TRANSMITTAL OF DEFENSE NUCLEAR FACILITIES SAFETY BOARD (DNFSB)  
RECOMMENDATION 2010-2 IMPLEMENTATION PLAN (IP) DELIVERABLE 5.5.3.5

Waste Feed Delivery Mixing and Sampling Program Simulant  
Definition for Tank Farm Performance Testing,  
RPP-PLAN-51625, Rev. 0, dated 03/20/12

ONE SYSTEM TECHNICAL TEAM RESPONSE TO REVIEW OF WASTE FEED  
DELIVERY AND SAMPLING PROGRAM SIMULANT DEFINITION FOR TANK FARM  
PERFORMANCE TESTING (ERT-12)

LSIMS ERT DOCUMENT REVIEW RECORD			REVIEW NUMBER:	ERT-12 Feed Simulant Defn.
			DOCUMENT NUMBER:	RPP-PLAN-51625 Rev. 0a
			DOCUMENT TITLE:	Waste Feed Delivery and Sampling Program Simulant Definition for Tank Farm Performance Testing
			Should we imply that Archimedes No. is the most relevant scaling parameter? See next comment.	
41	RVC	O	Section 6 & Appendix C: Eqns. 6.1 & 6.2 show the relation between settling velocity and Archimedes No. Why are both plotted (Figs.C-1 & C-2)? The broader question is what is the point of having eight different ways to look at things if some are repetitive and others are not physically relevant? You have already heard about Zwietering. No matter how well all 8 are justified, it still looks like smoke to the less informe

Figure 6-1. Cumulative Volume Distribution of Hanford Waste Liquid Density

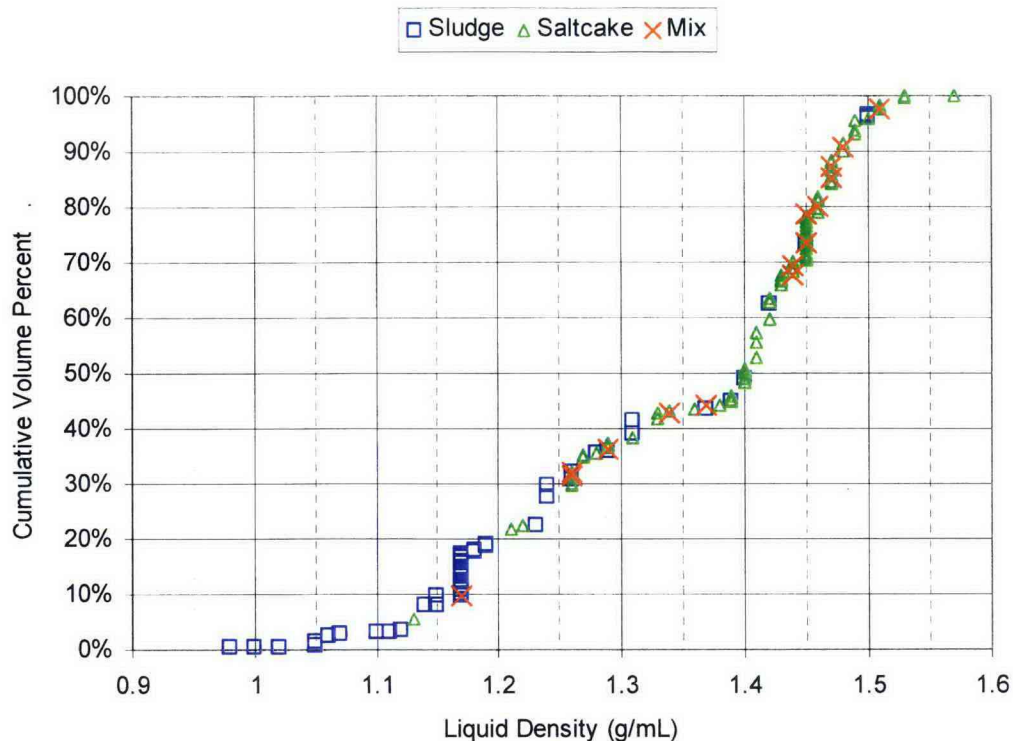
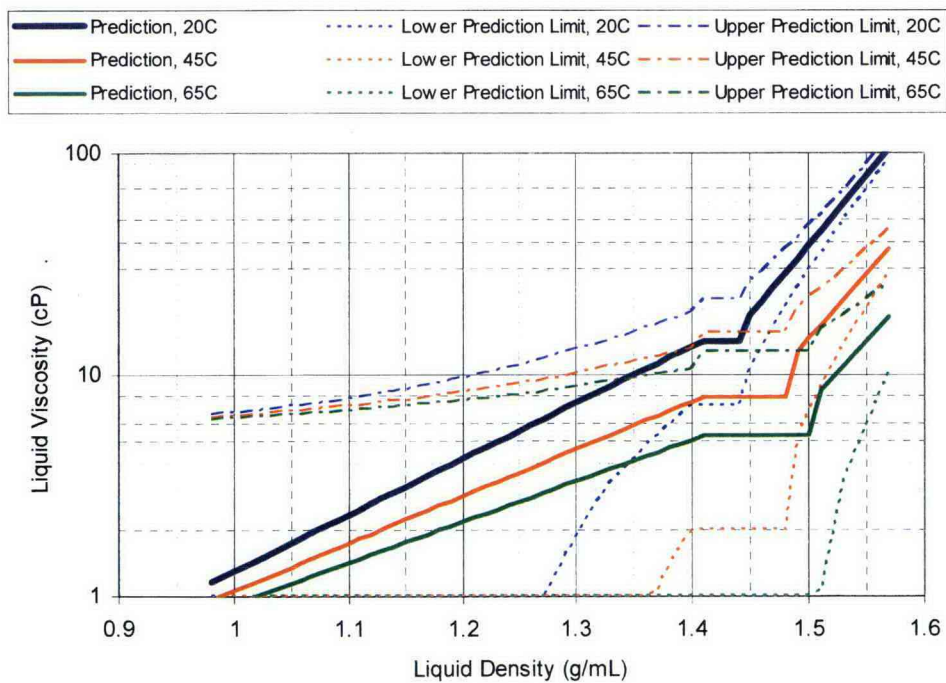
33	RVC	E	Section 6: Some captions and figures need to be re-aligned.	Corrected
34	RVC	O	Figures 6.1 & 6.2: In the figures, is there an interdependence between density and viscosity? Or can any combination of wastes yield a particular density?	See the discussion in Section 6.1
35	RVC	E	p.23, 3 <sup>rd</sup> paragraph: Numerous incorrect references to Figures.	Corrected
36	RVC	O	Naïve question: Why is the waste Bingham? Am I wrong to suspect that tank farm wastes may have sufficiently deviant rheology?	The Bingham rheological model is considered imperfect, but appropriate for these purposes.
37	RVC	O	Section 6.2: Figs.6.3 to 6.14 are too much, especially given the scatter plot like nature of the non-cumulative plots. Dealing with them diffuses the message, so except for a few, examples, they should be put in an appendix.	This section has been modified.
38	RVC	O	Section 6.2: If expected trends do not always occur, what does that say about the quality, accuracy and representativeness of the data?	This section has been modified for clarity.
